BRUNSWICK STEAM ELECTRIC PLANT, UNIT 2

AMENDMENT TO FACILITY OPERATING LICENSE

Amendment No. 149
License No. DPR-62

ATTACHMENT TO LICENSE AMENDMENT NO. 149

Figure 3.2.1-1

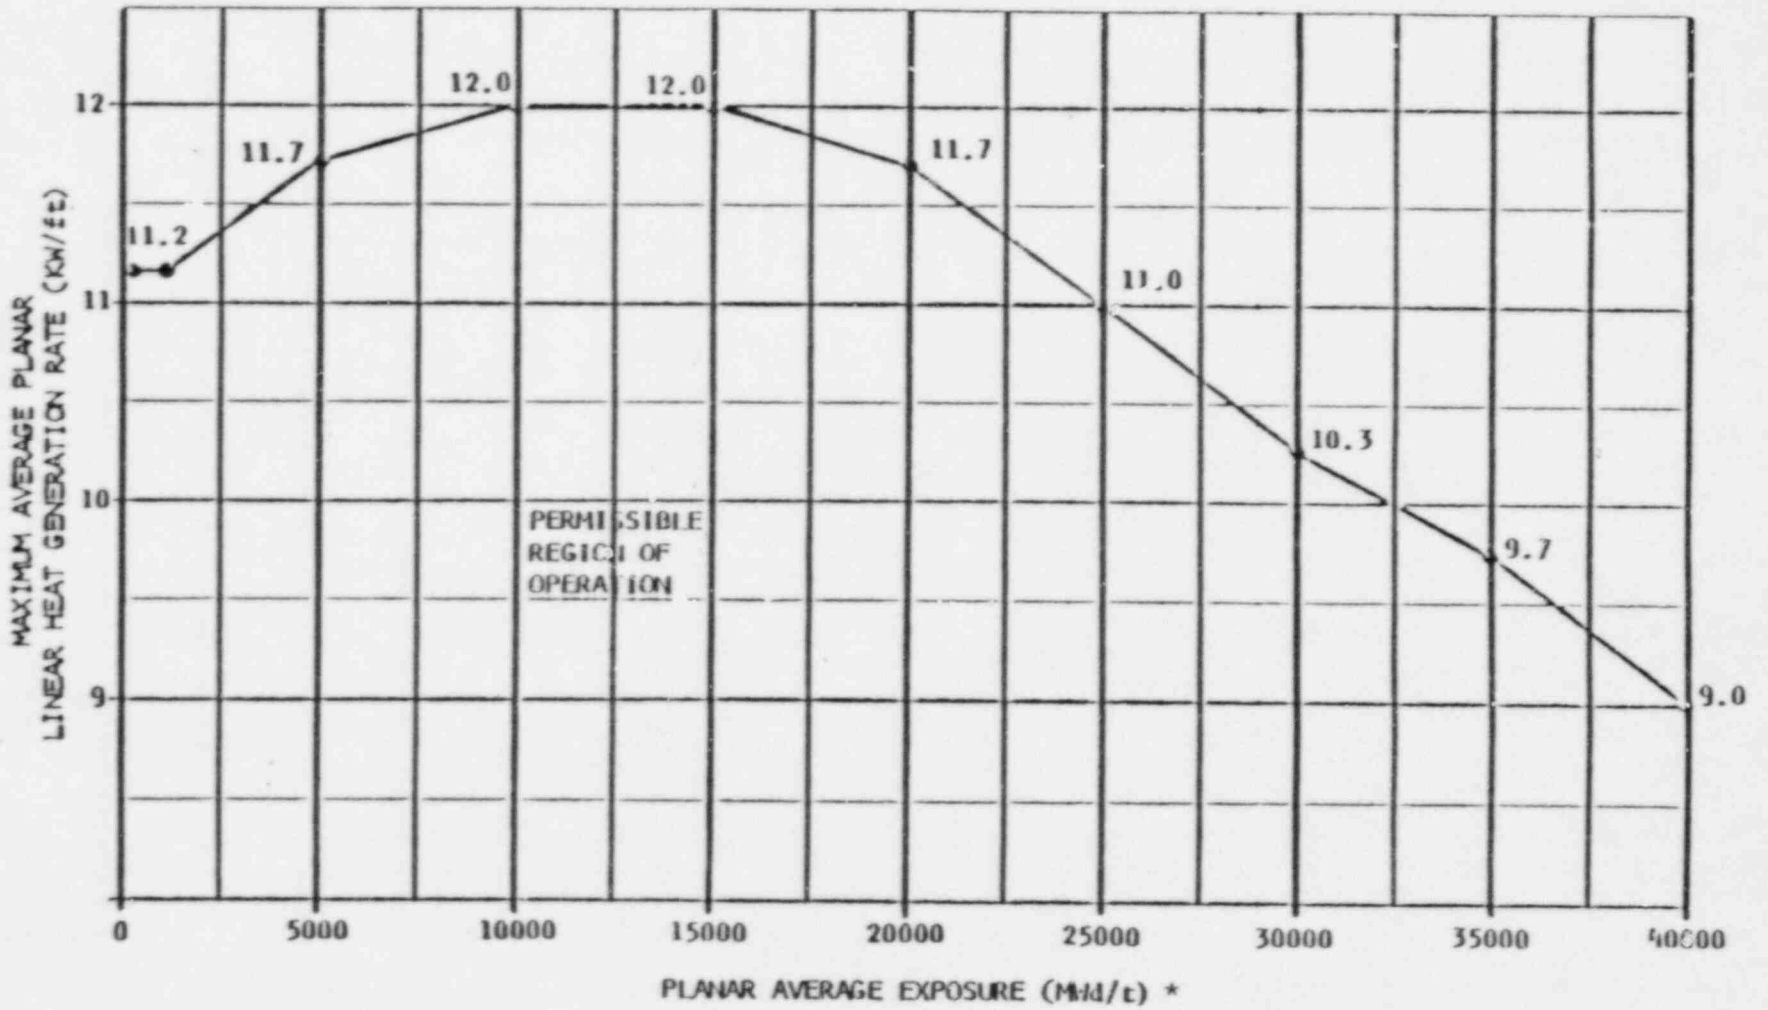
FUEL TYPE P80XB265H (P8X8R)
 MAXIMUM AVERAGE PLANAR LINEAR HEAT
 GENERATION RATE (MW/FT)²
 VERSUS PLANAR AVERAGE EXPOSURE

*Amendment 149 authorizes operation only up to an average fuel bundle burnup of 33,000 MWd/MT

Figure 3.2.1-2

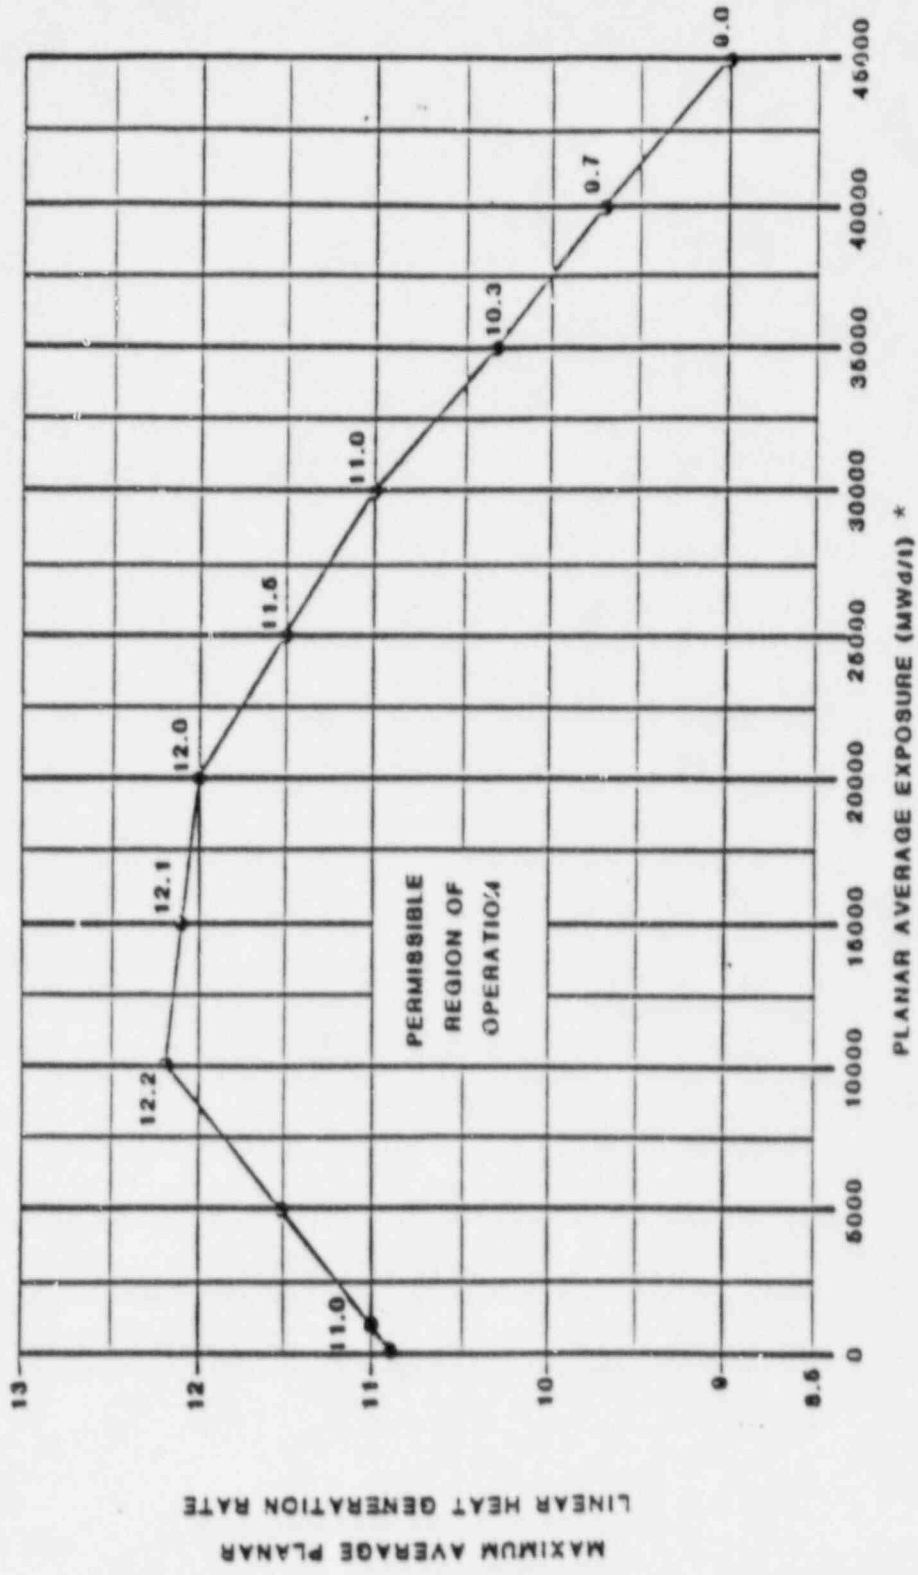
FUEL TYPE P8DRB284H (P8X8R)
MAXIMUM AVERAGE PLANAR LINEAR HEAT
GENERATION RATE (MAPLHGR)
VERSUS AVERAGE PLANAR EXPOSURE

*Amendment 149 authorizes operation only up to an average fuel bundle burnup of 33,000 MHD/MT

Figure 3.2.1-3

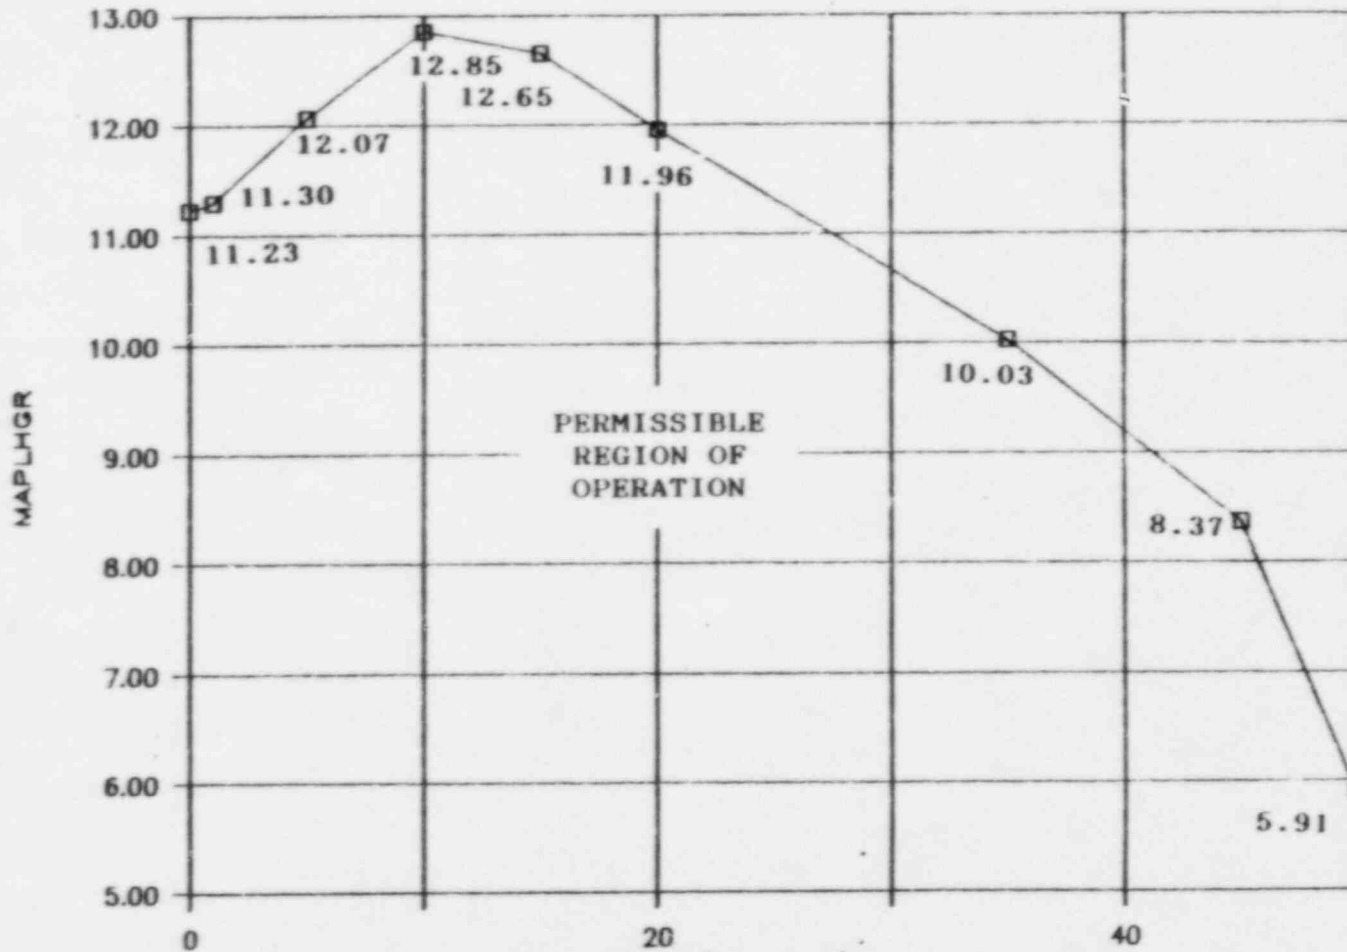
*Amendment 149 authorizes operation only up to an average fuel bundle burnup of 33,000 MWD/MT

(Thousands)
PLANAR AVERAGE EXPOSURE (MWd/t) *
Figure 3.2.1-4
FUEL TYPE BD317A (GE8)

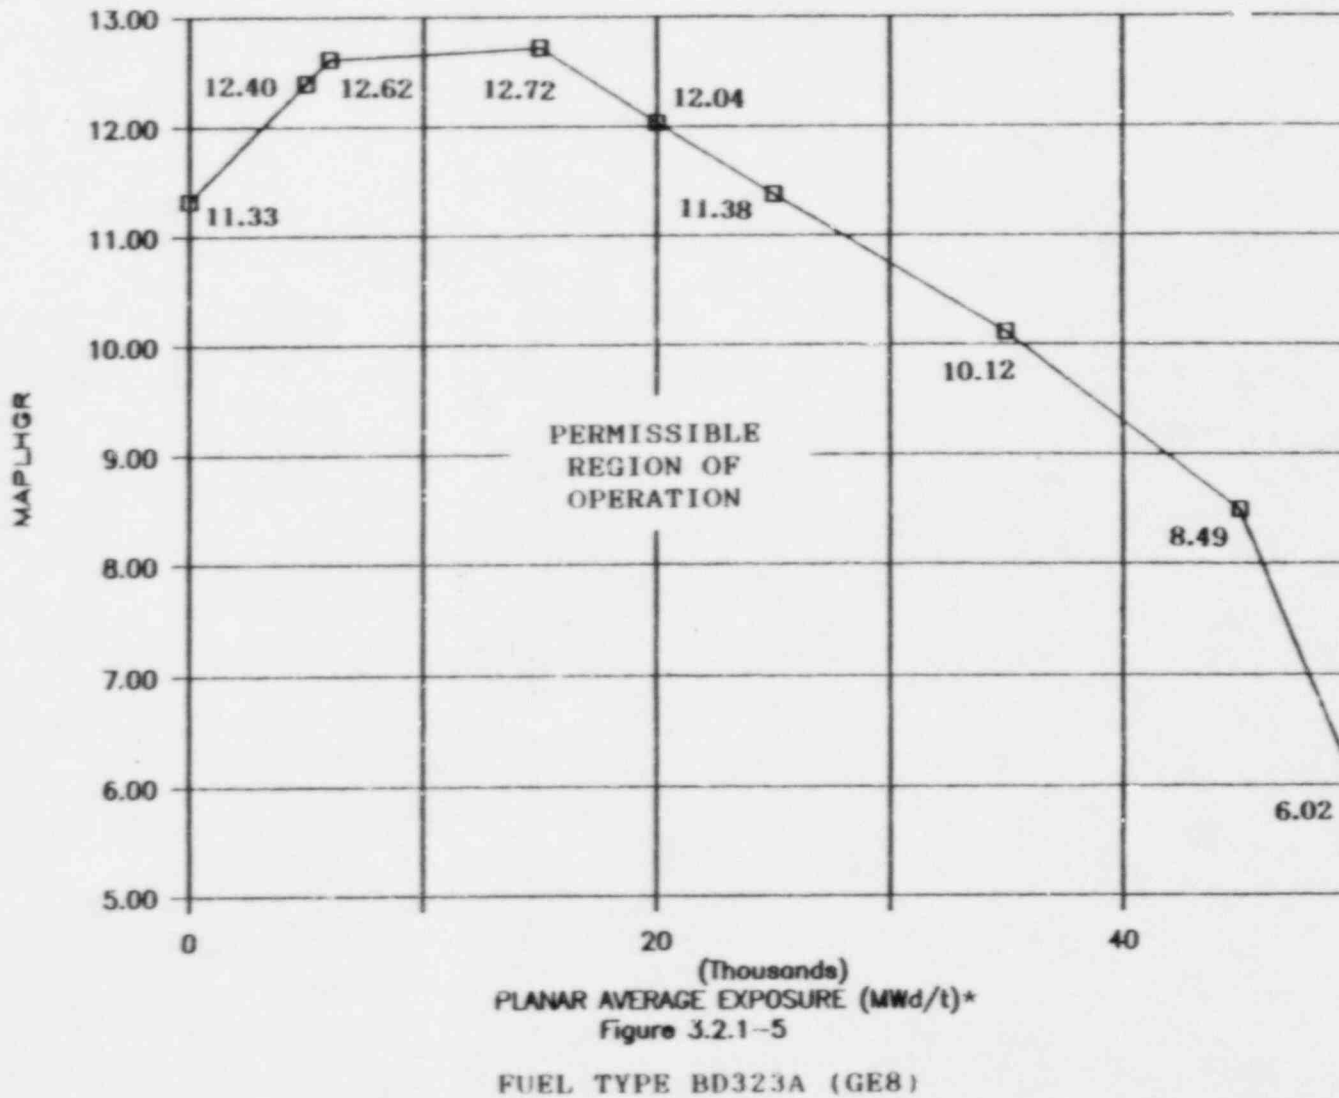
NOTE: This curve represents the most limiting APLHGR to be used for hand calculations. The limiting values for each lattice are in the core monitoring system.

*Amendment 149 authorizes operation only up to an average fuel bundle burnup of 33,000 MWd/MT
